# UNITED STATES PATENT AND TRADEMARK OFFICE

APPLICATION NO.	FILING DATE	FIRST NAMED INVENTOR	ATTORNEY DOCKET NO.	CONFIRMATION NO.
10/737,311	12/16/2003	Dennis Kelly	1-24296	5955

<b>Office Action Summary</b>	<b>Application No.</b> 10/737,311	<b>Applicant(s)</b> KELLY ET AL.	
	<b>Examiner</b> Melody M. Burch	<b>Art Unit</b> 3683

**DETAILED ACTION**

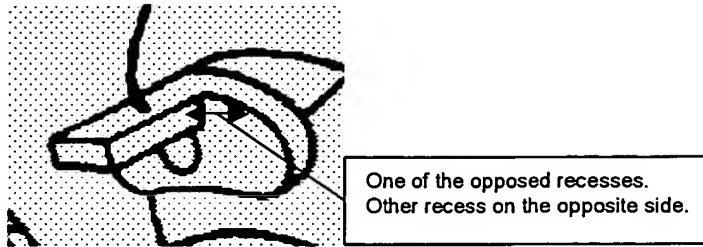
Re: claims 30 and 44. Opposed recesses are shown below in the modified version of a portion of Anger et al. figure 3.

Re: claim 38. Opposed recesses are shown in the modified version of a portion of Anger et al. figure 3 on pg. 4 of the Office action.
